**ADDENDUM 6**

**DATE: August 17, 2020**

Contract 19-C-00018; E. Columbus Drive from N Nebraska Ave (SR45) to 14th St. Bike Lane/Sidewalk –  
FDOT LAP

FISCAL YEAR	SHEET NO.
21	1

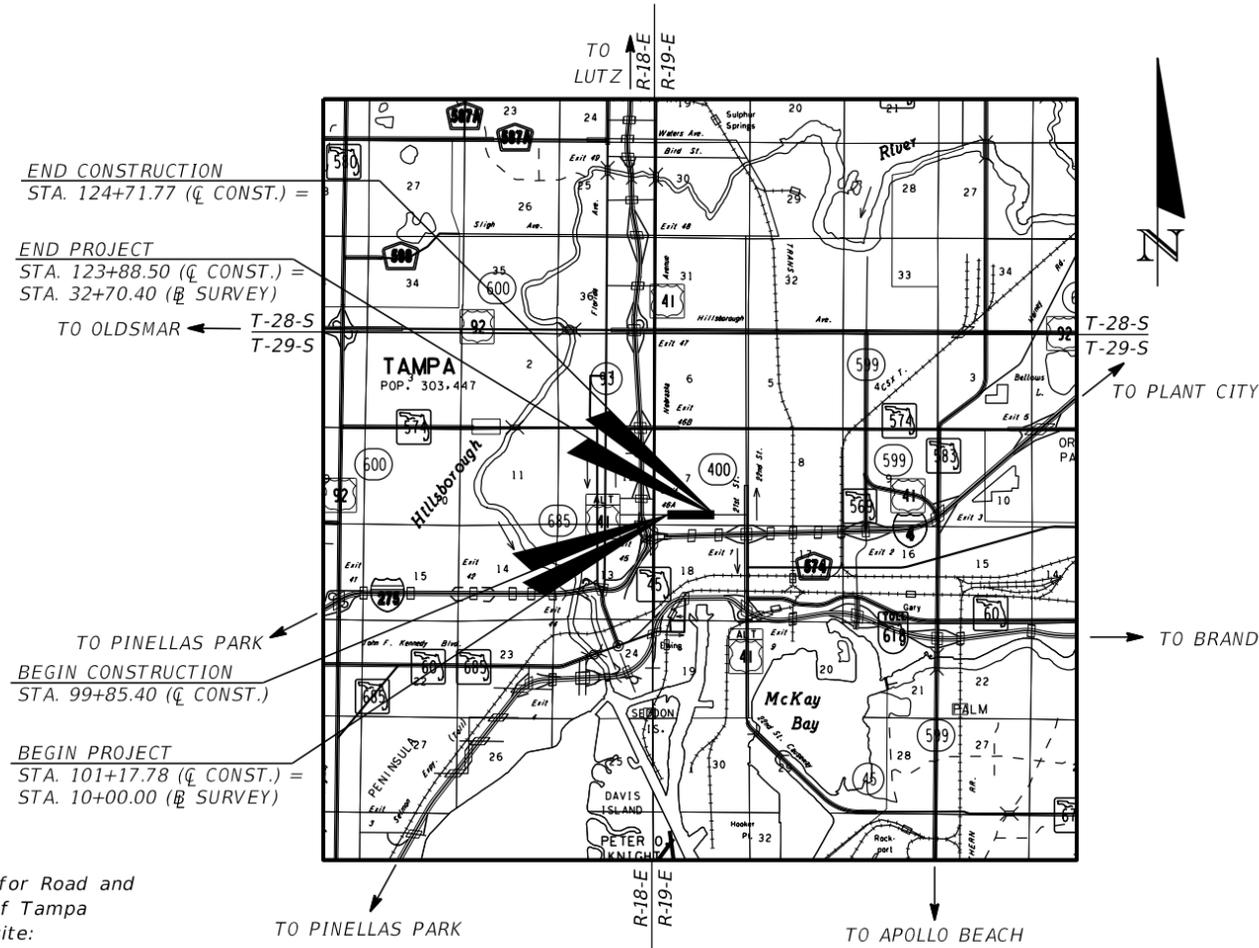
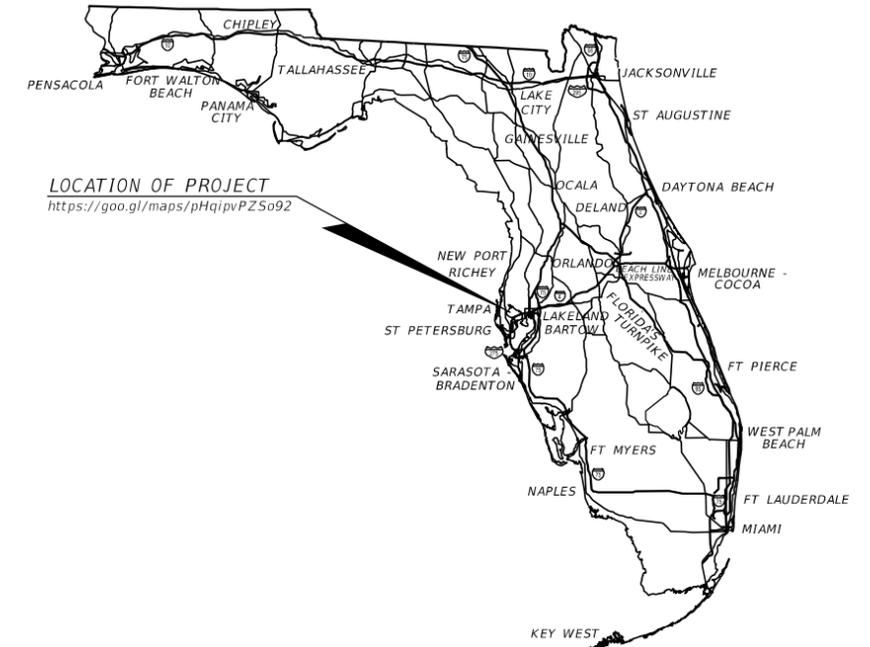
- △ Roadway Sheets 1 & 2A
- △ Roadway Sheets 1, 2A, 3, & SQ-1 UWHCA Sheets U-1 & U-2

KEY SHEET REVISIONS	
DATE	DESCRIPTION
07-09-20	Added Sheet Number 2A, Revised Standard Specifications and Standard Plans Date
08-11-20	Added Sheet Number 2B

FISCAL YEAR	SHEET NO.
21	U-01

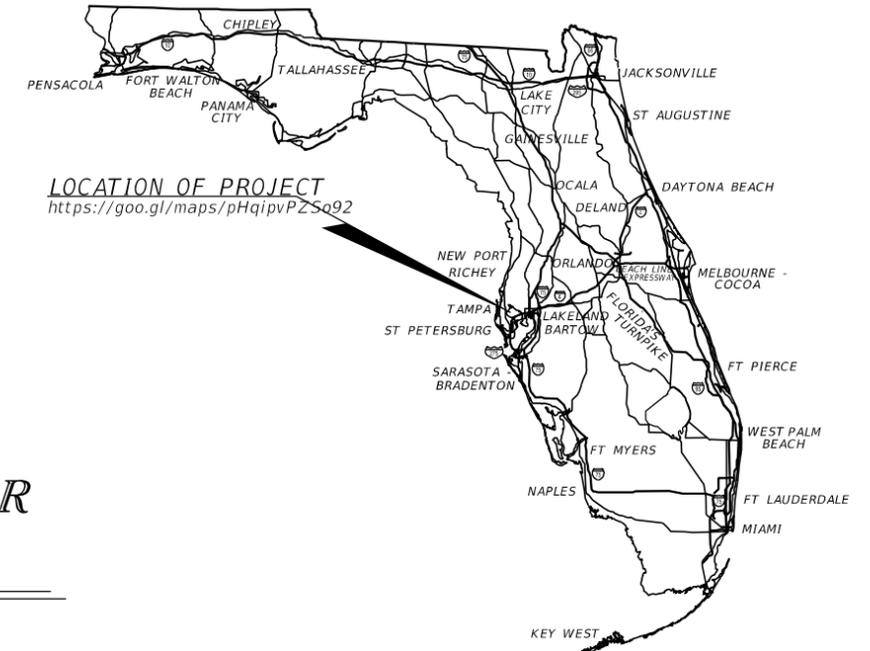
△ UWHCA Sheet U-01 and U-02. (Revised 08-04-20)
